Supplement No. 1

Service Bulletin No. 543A

This Supplement No. 1 to Service Bulletin No. 543A provides an alternate means of compliance with Service Bulletin No. 543A.

Figure A

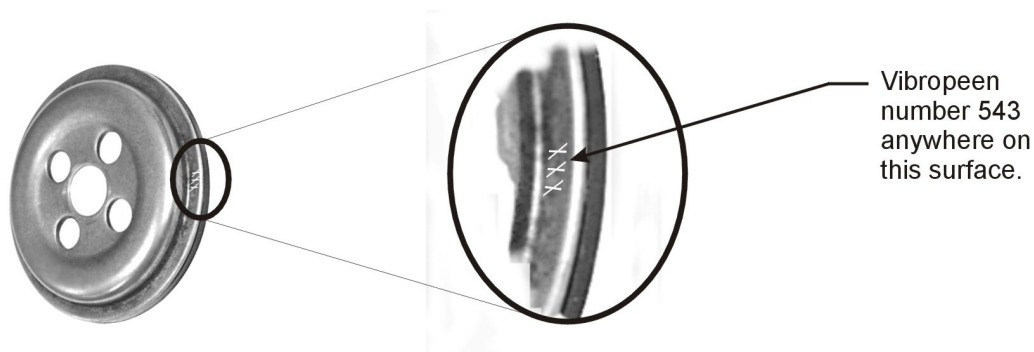
1. Replace the P/N LW-13388 gasket with a new gasket P/N 06B23072 in accordance with Textron Lycoming Service Instruction No. 1453. For identification, new gaskets P/N 06B23072 have been stamped with their part number.
2. After bonding the P/N 06B23072 gasket in place, vibropeen the number 543 anywhere along the outer surface of the plate flange as shown in Figure A.
3. Reinstall the plate and oil filter in accordance with Service Instruction No. 1453. This relieves the requirement of the replacement of the converter plate gasket at every 50 hours.

**After converter plate is marked with 543, P/N LW-13388 gasket may never be used again.**
